ADDENDUM NO.1

Date: **June 28, 2021**

Subject: **Addendum No.1 to Contract Documents
City of Mercer Island
Booster Chlorination System Project (Bid #21-28)**

VERIFY SCALES	JOB NO. 11540C.10
BAR IS ONE INCH ON ORIGINAL DRAWING	DRAWING NO. E07
IF NOT ONE INCH ON THIS SHEET, ADJUST SCALES ACCORDINGLY	SHEET NO. 32 OF 55

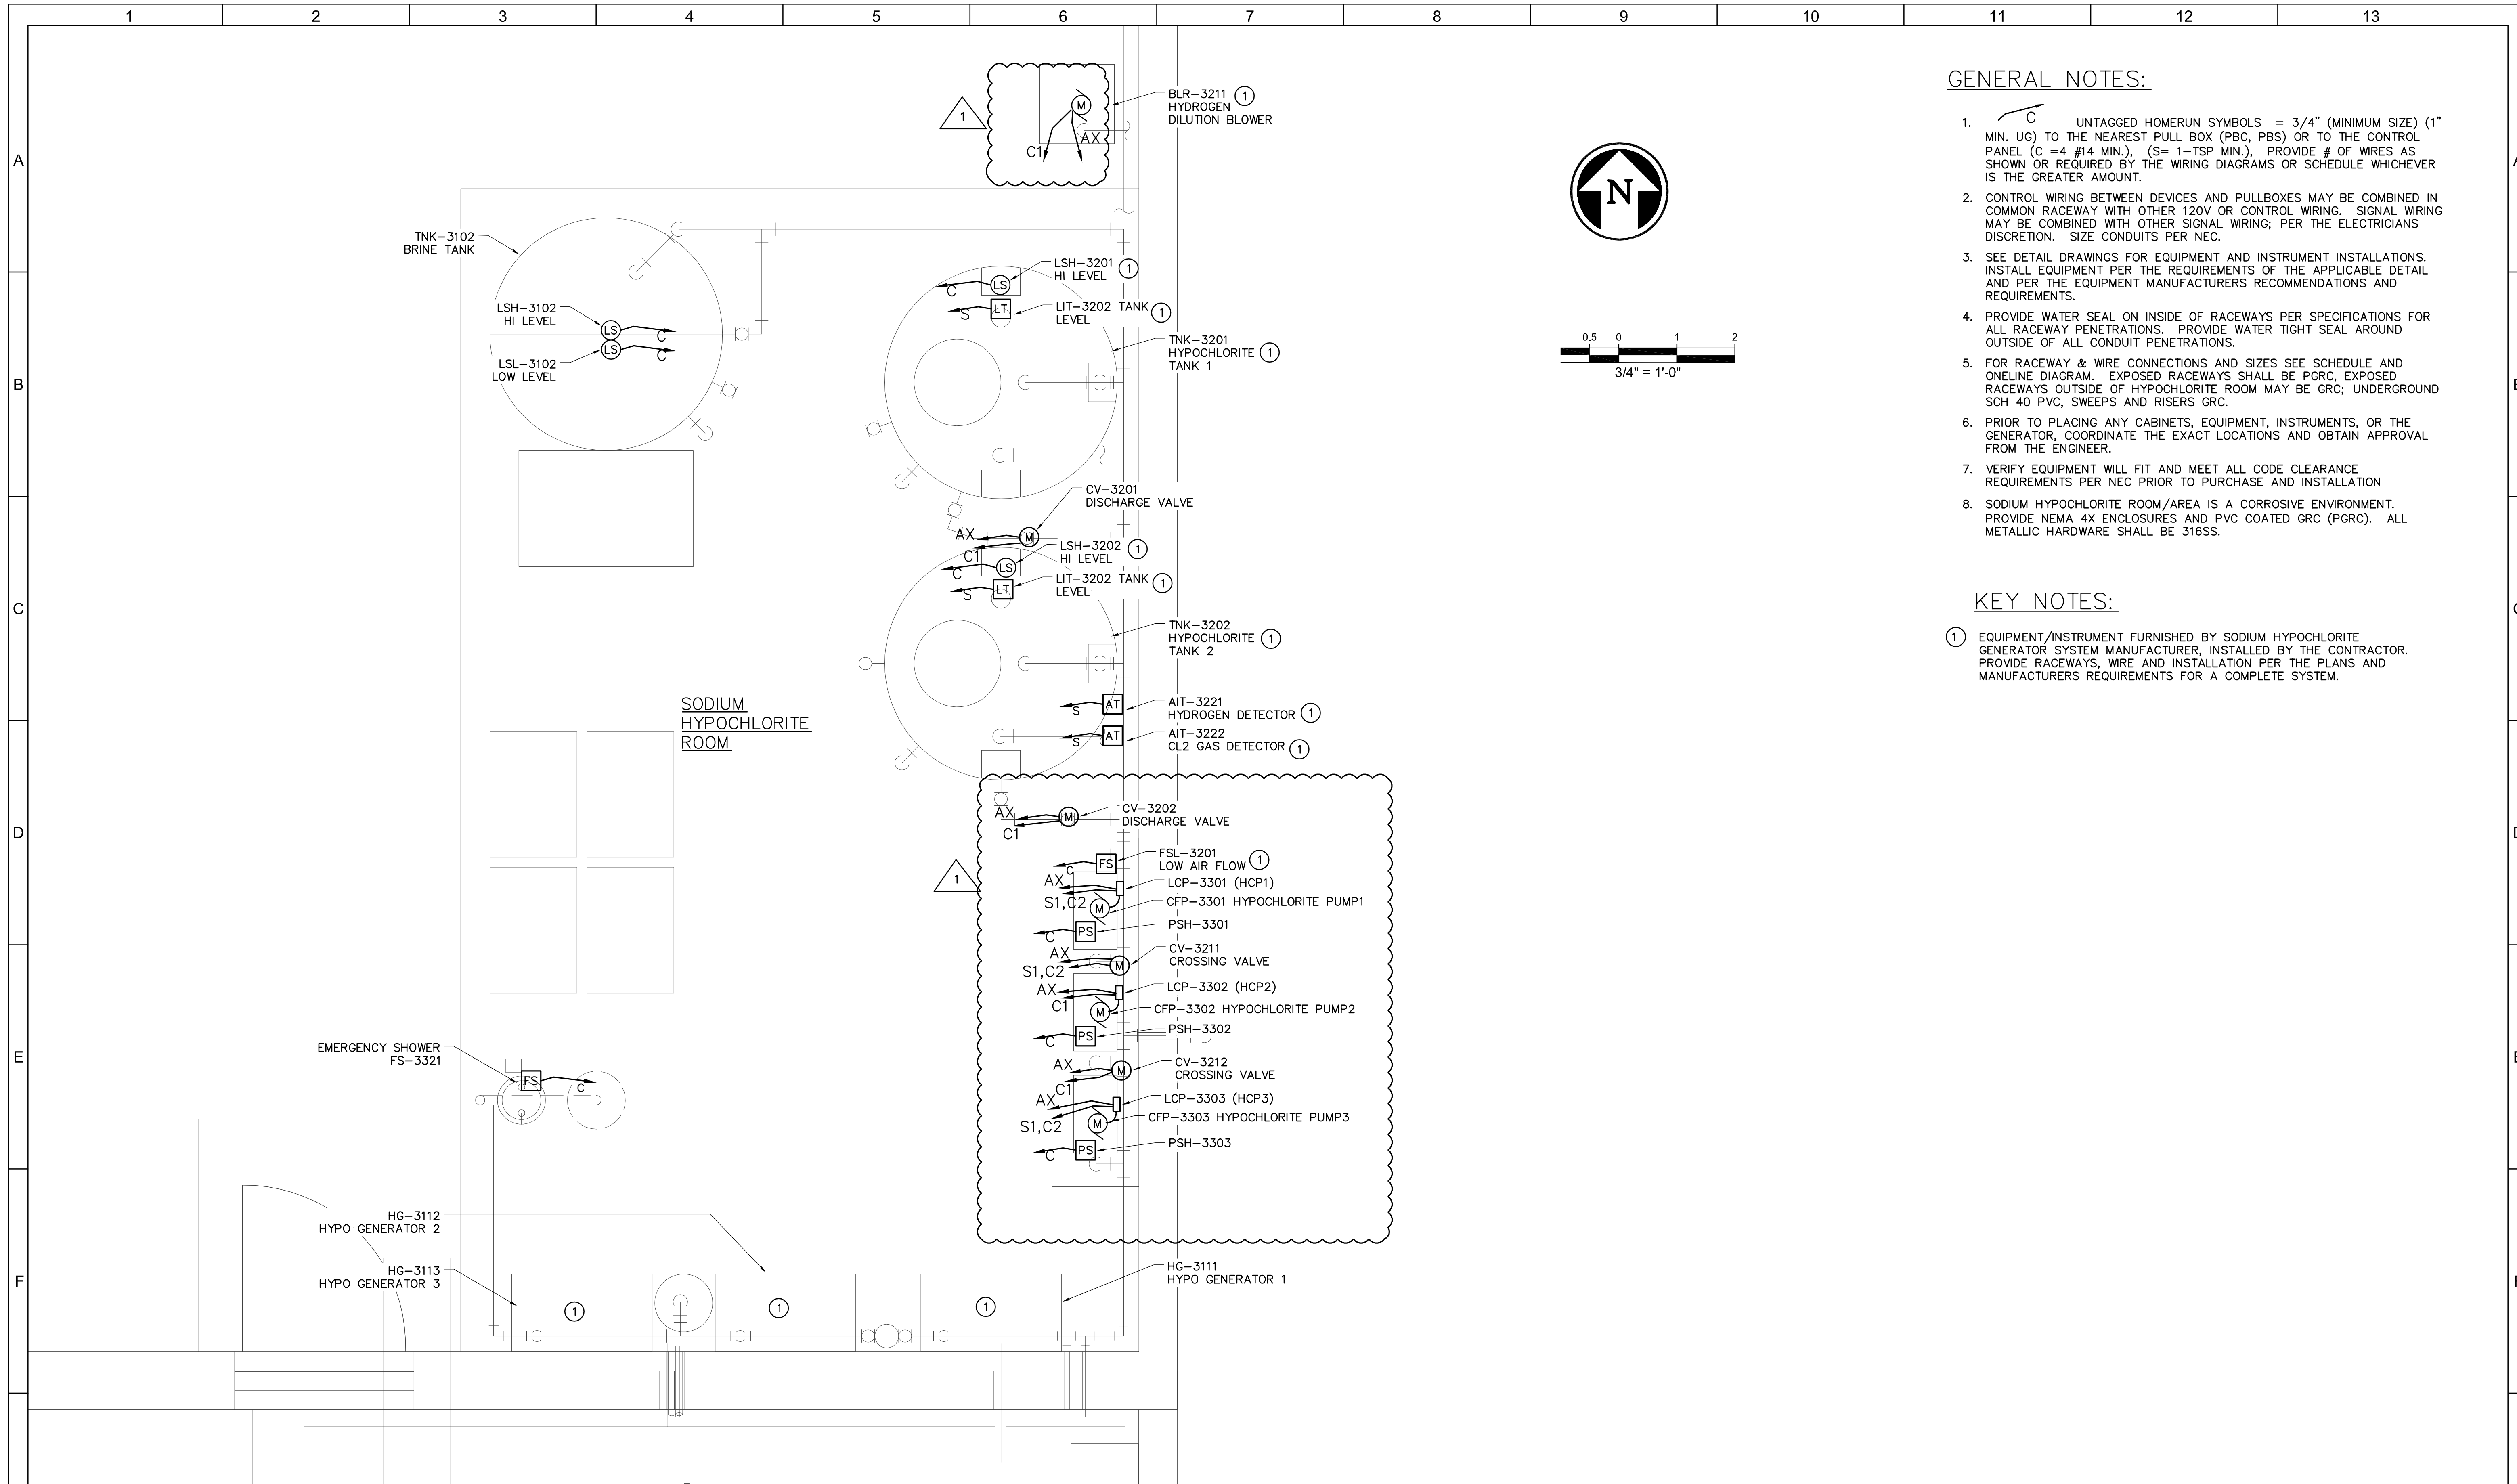
- 15) On drawing E04, EUH-3601 Heater and thermostat are shown on the one line. Please indicate where on the drawings this is located? We don’t see it on the floor plan anywhere

Response: EUH-3601 heater will be located on the north wall in the Sodium Hypochlorite Room with the thermostat on the south wall as shown below. This update will be included in a future addendum (see Addendum 1).

JOB NO. 11540C.10
 DRAWING NO. E12
 SHEET NO. 37 OF 55

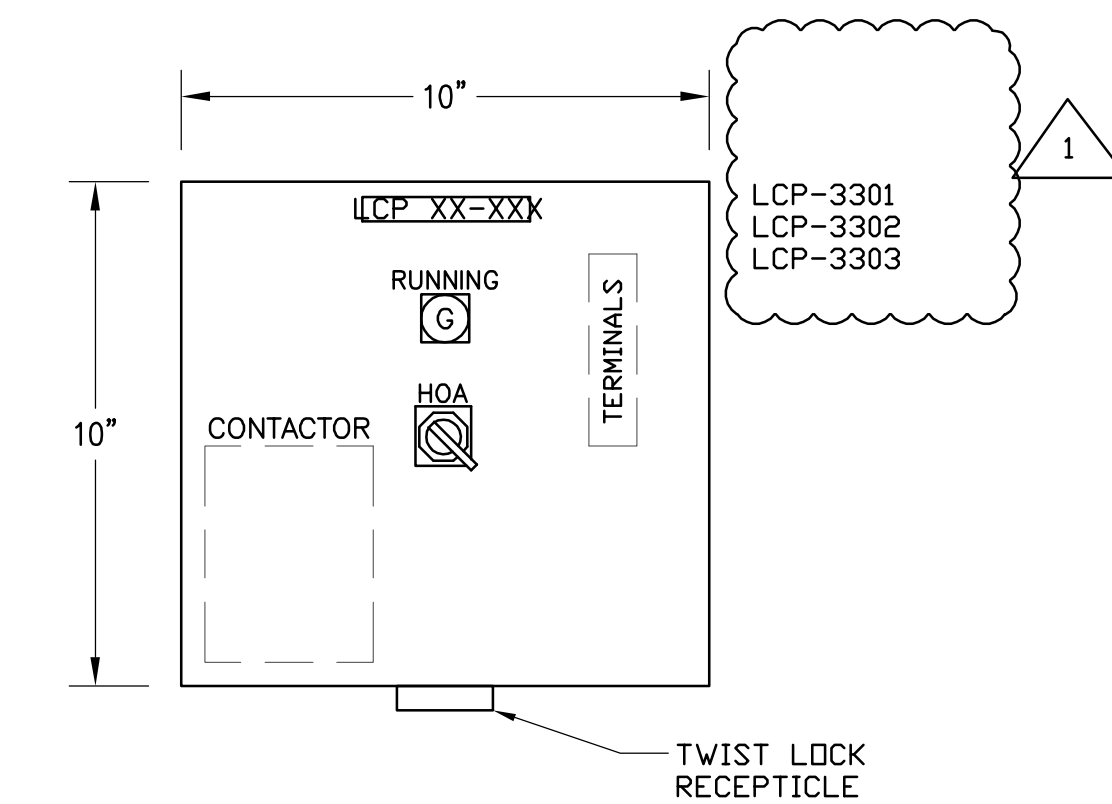
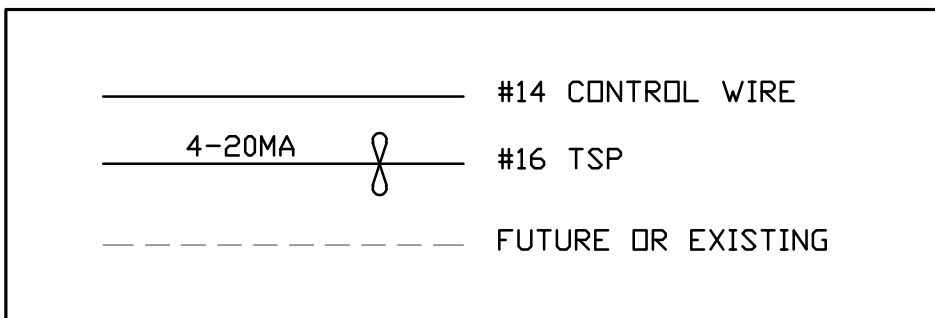
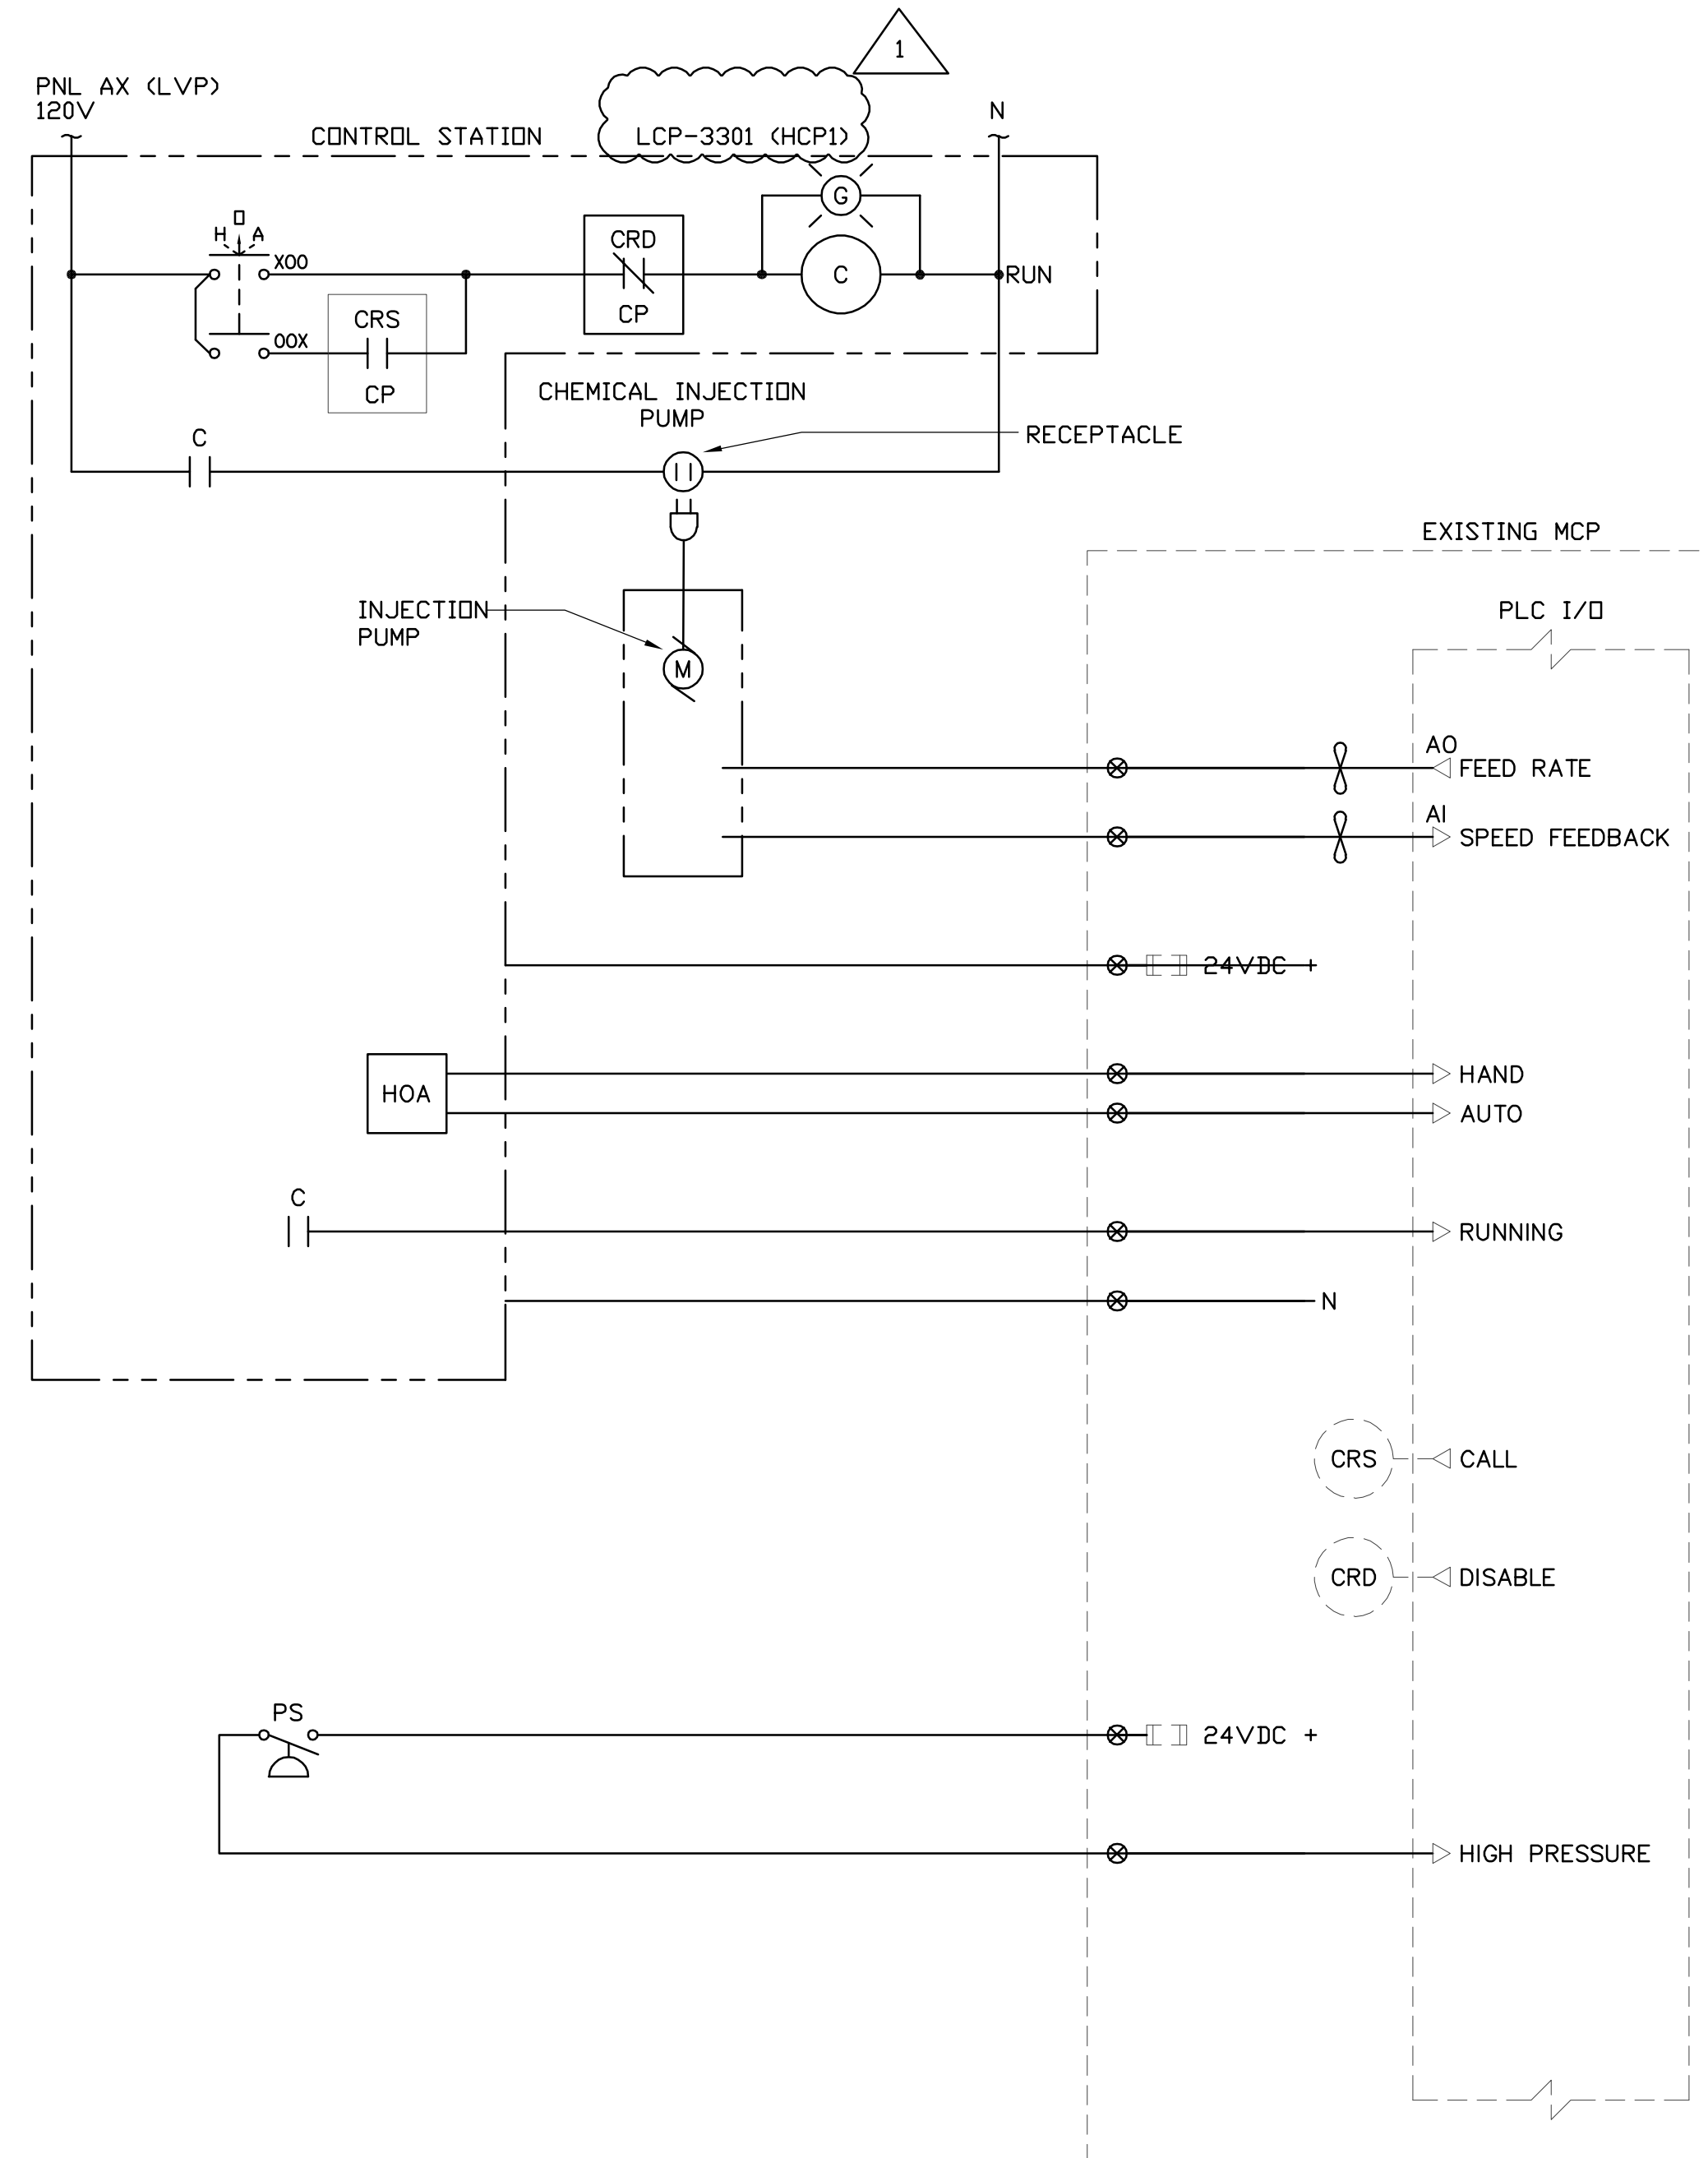
- CFP-3301 Hypochlorite Pump 1
- CFP-3302 Hypochlorite Pump 2
- CFP-3303 Hypochlorite Pump 3

Hypochlorite pumps also have a power panel for each one shown on the wire diagrams, Drawing E12 and P&ID Drawing N05. This item will be clarified in a future addendum (see Addendum 1).
